**Re:     Transportation Impact Study  
        Plan of Subdivision/Common Element Condominium Applications  
        231 – 245 Reach Street, Township of Uxbridge  
        Our Project No. NT-17-215**

On behalf of Venetian Development Group (the “client”), we acknowledge AECOM’s transportation comments on behalf of the Township of Uxbridge dated June 3<sup>rd</sup>, 2021 (provided in **Appendix A**) with respect to our Transportation Impact Study, dated January 26, 2019.

**Site Plan Clearance Table**  
**AECOM Comments – June 3, 2021**  
**In conjunction with**  
**Draft Approved Plan of Subdivision S-U-2018-01**  
**Reach Street, Uxbridge**

**Figure 2-2: Stopping Sight Distances**

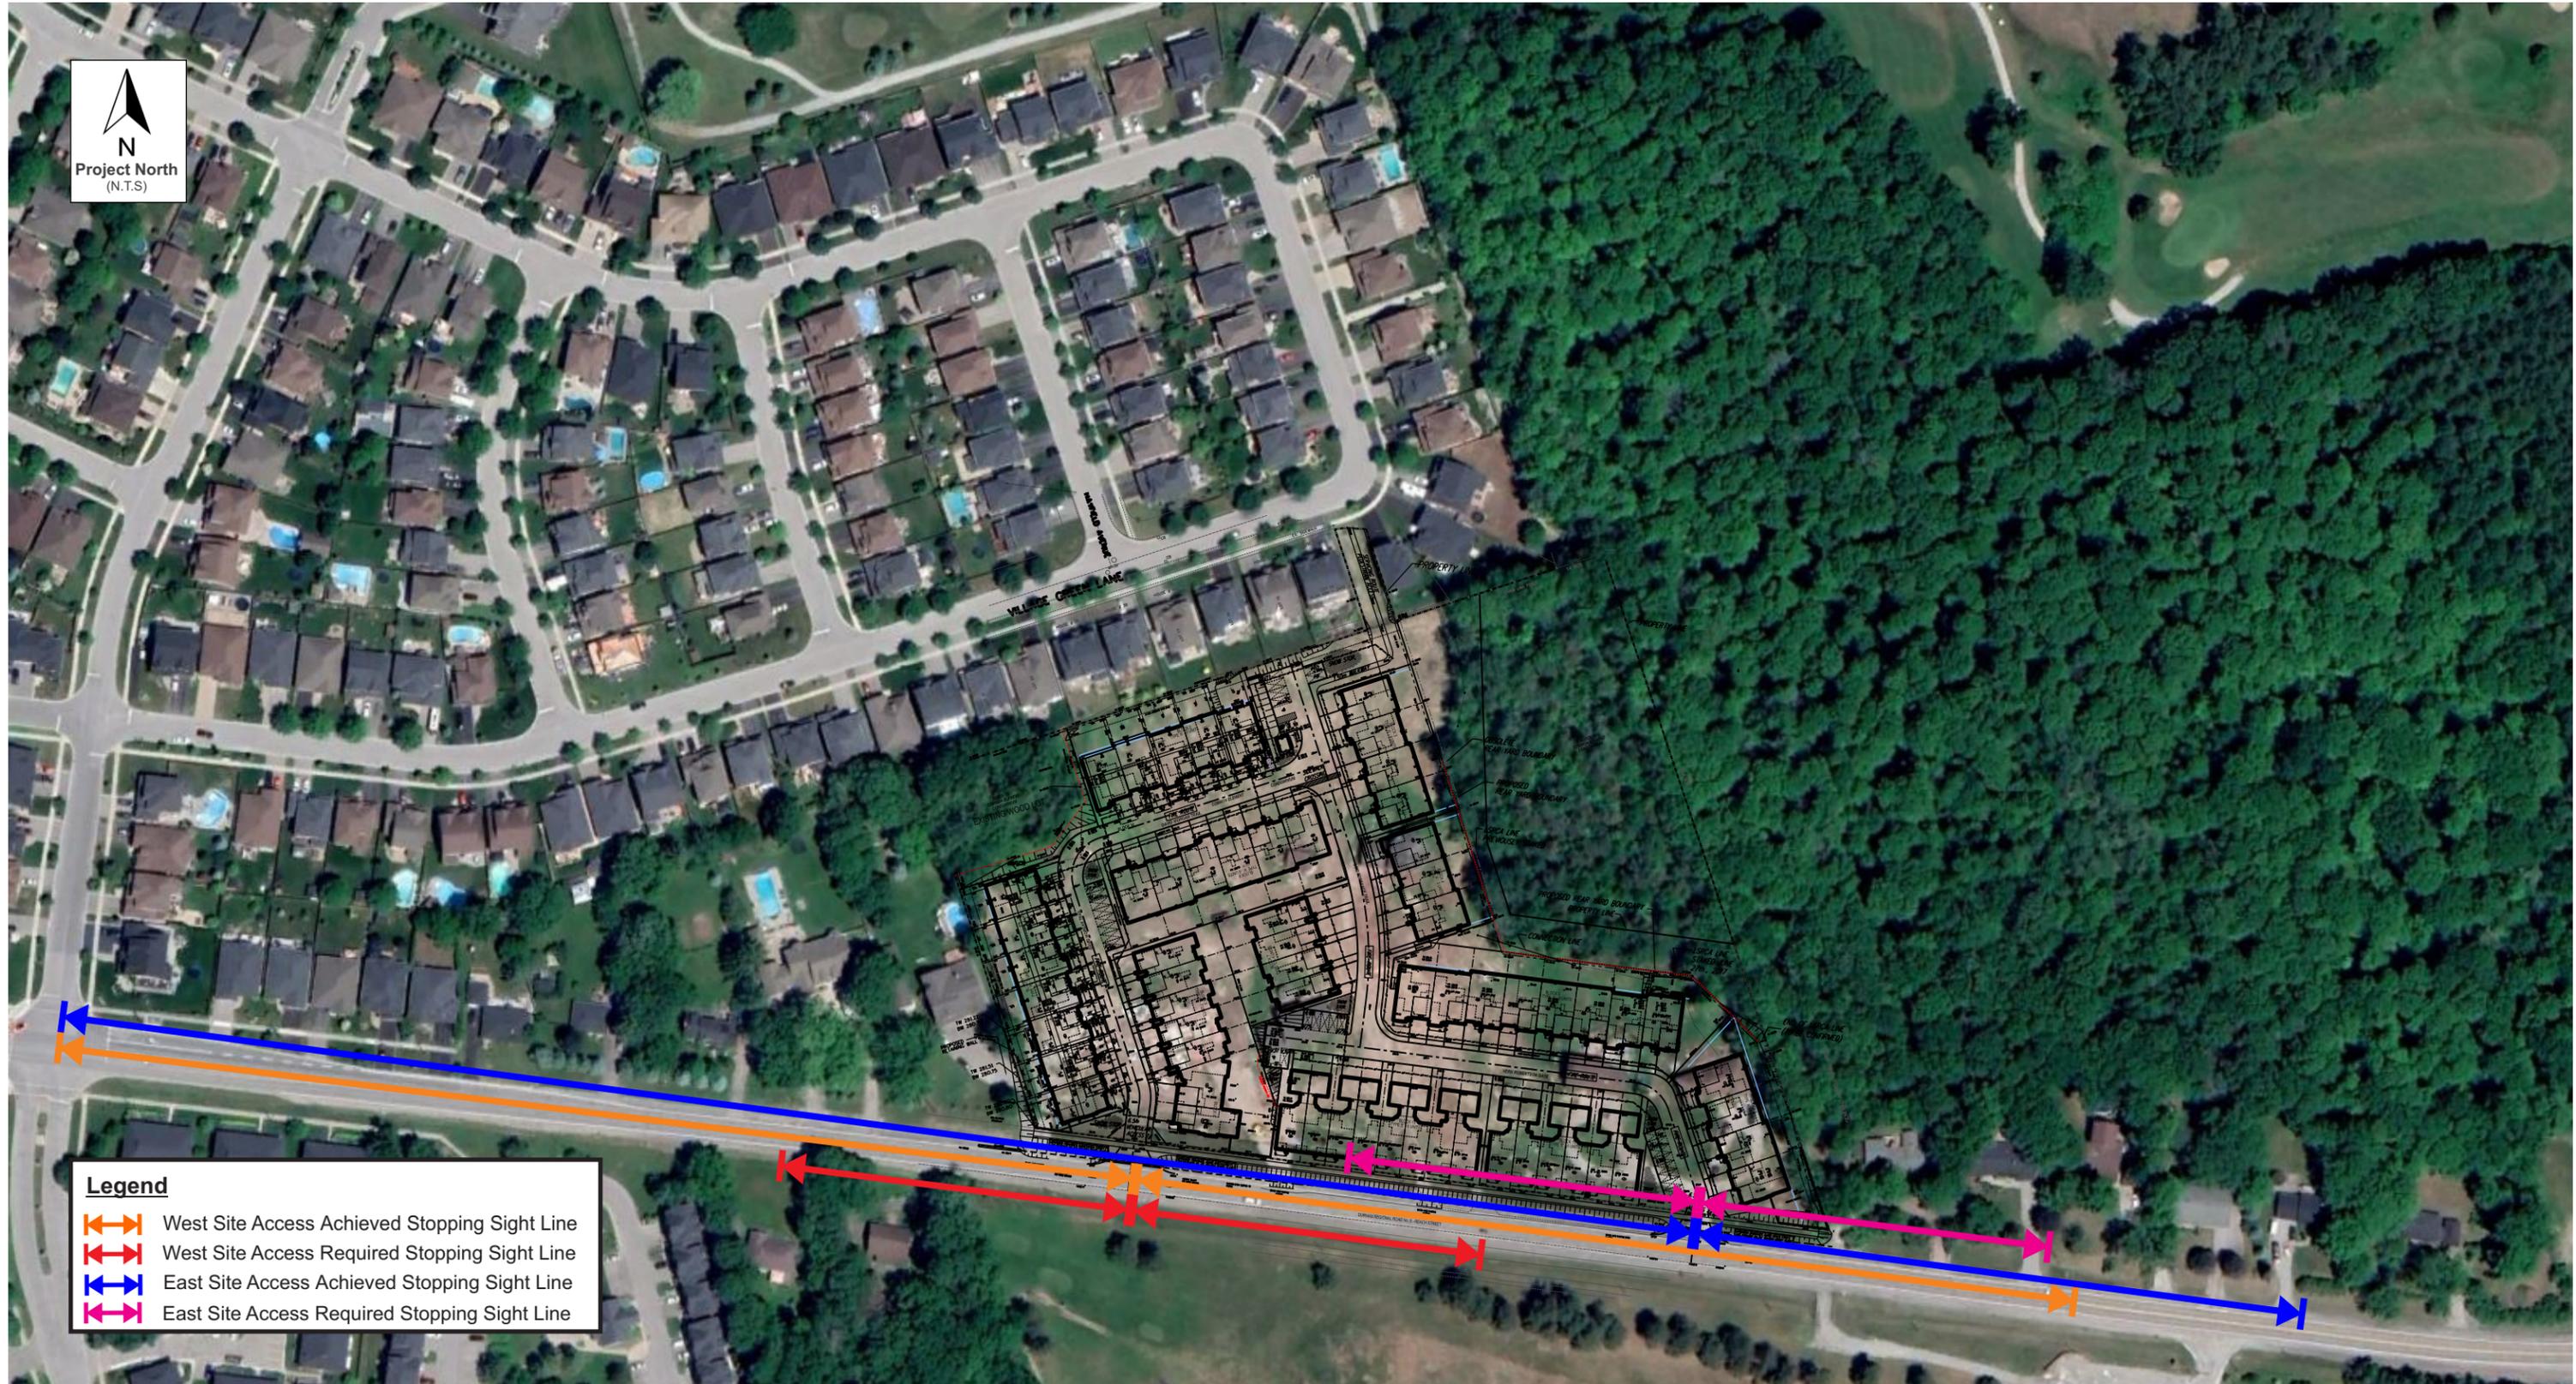
1. *Please provide sight line calculations for the entrances to the property.*

**Response** – Acknowledged. See **Section 2.0** which contains the calculations for the sight line analysis.

Existing sight distances approaching the proposed site access have been determined through an on-site visit. The on-site observations are illustrated in **Figure 2-1** and the required and achieved stopping sight distances are illustrated in **Figure 2-2**. The stopping sight distances at the proposed site access via West Street are summarized in **Table 2.1**.

Site Access	Approach	Stopping Sight Distance		
		Required	Achieved	Difference
East Site Access	Eastbound	110 m	185 m	+75 m
	Westbound		475 m	+365 m
West Site Access	Eastbound		295 m	+185 m
	Westbound		340 m	+230 m

As summarized in **Table 2.1**, the required stopping sight distance for both site accesses, eastbound and westbound approaches is 110 m, respectively. Based on the site visit conducted, the achieved stopping sight distance for the east site access west approach is 185 m and the achieved sight distance for the east approach is 475 m and for the west site access west approach is 295 m and the achieved sight distance for the east approach is 340 m. In comparing the difference between the required and the achieved stopping sight distances for the east site access west and east approaches, there is a surplus of 75 m and 365 m, respectively; and for the west site access west and east approaches, there is a surplus of 185 m and 230 m, respectively. **Therefore, it is our opinion that there is adequate stopping sight distance for the proposed driveway.**
